Comment #142: Description of Mapping

John D'Ambrosia, Force10 Networks

Introduction

Excerpt from IEEE P802.3ba Draft 2.2 Fig 83-6

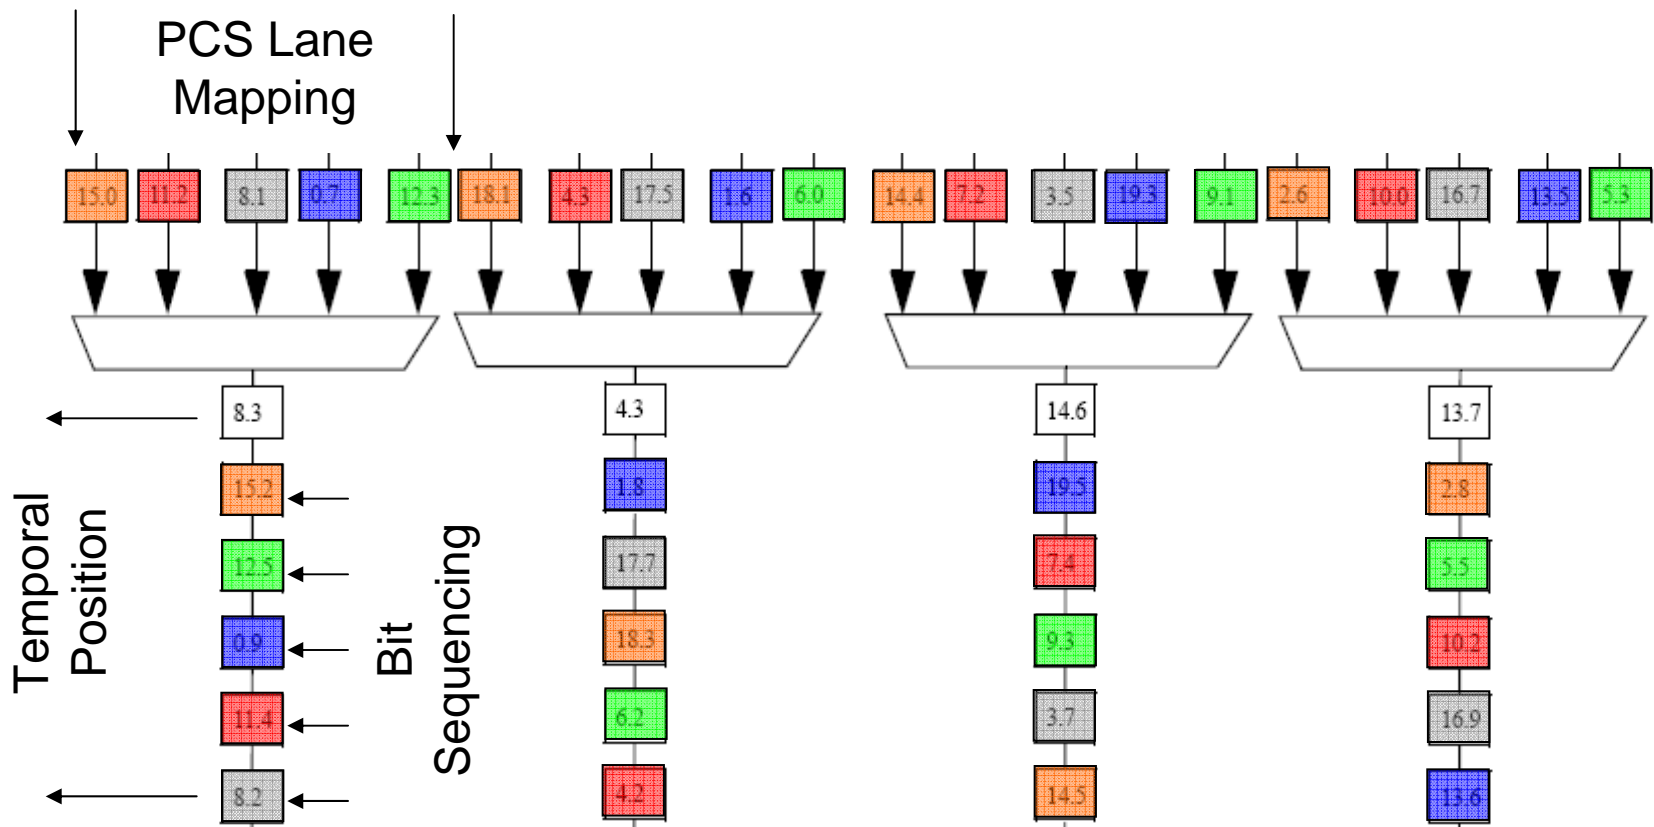
- Reference Comment #142 (D'Ambrosia) against D2.2:
- There is some concern regarding the use of the term mapping and how it relates to what is illustrated in Fig 83-6. The use of the word "mapping" seems to address how input lanes are directed to output lanes, but in the commenter's opinion does not do an adequate job addressing the sequencing of bits on the output lanes, which may lead to interpretation issues.

- Mapping and sequencing are not specified
- May not change once link is brought up
- May change between successive times that a given link is brought up
- But text focuses only on mapping and does not address sequencing
- Will this be clear to those who have not been involved in IEEE P802.3ba?
- See marked up text in dambrosia_03_0909 for discussion
